## FINAL ORDER

The Special Standards Request Form you submitted for owner: Elk River Property Development, Start Card number 1076288, is hereby approved for the following: You may alter this water supply well (CURR 53312) as described on your Special Standards Request Form dated December 20, 2024. with a couple of stipulations as described below:

# Special Standards Request Form

SEE Attached Drawing

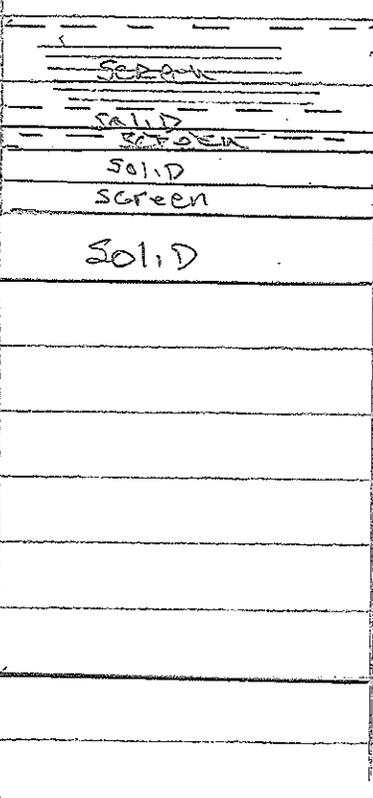
Adequate for this Well (attach additional pages if needed): Set 6" SDR 21

0-140', Sch 80 PVC 150-155, 160-165, 170-178 (Tail Pipe

- ***The Sch80 PVC casing shall conform to ASTM D1785 and meet the standards of the National Sanitation Foundation.***
- ***The Sch80 PVC casing shall not extend beyond a depth of 200 feet.***
- ***The Sch80 PVC casing shall not be used in the annular seal interval.***
